WORTHINGTON, SKILLING, HELLE & JACKSON — Civil & Structural Engineers

PROJECT THE WORLD TRADE CENTER | TITLE CONNECTION DETAIL 175 A | DATE 7-28-67

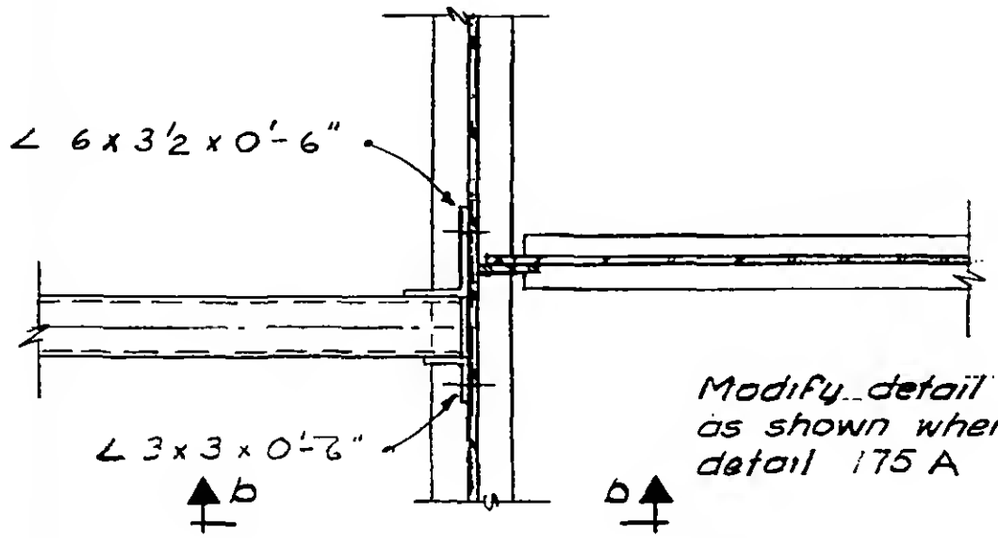
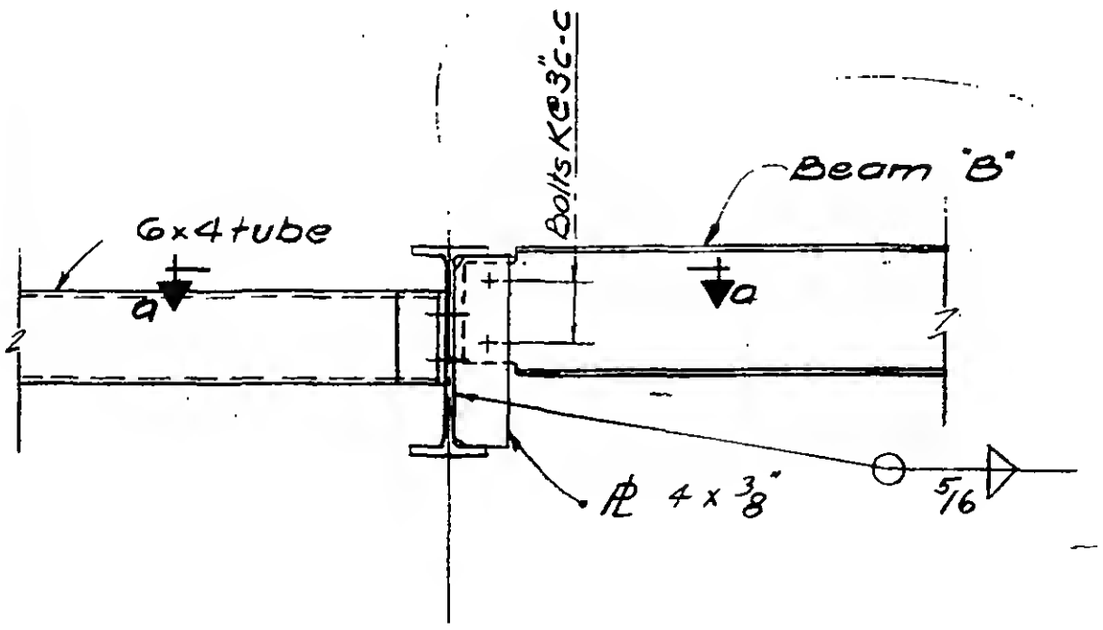
Modify detail 451 (For 6x4 tube) as shown when combined with detail 175 A
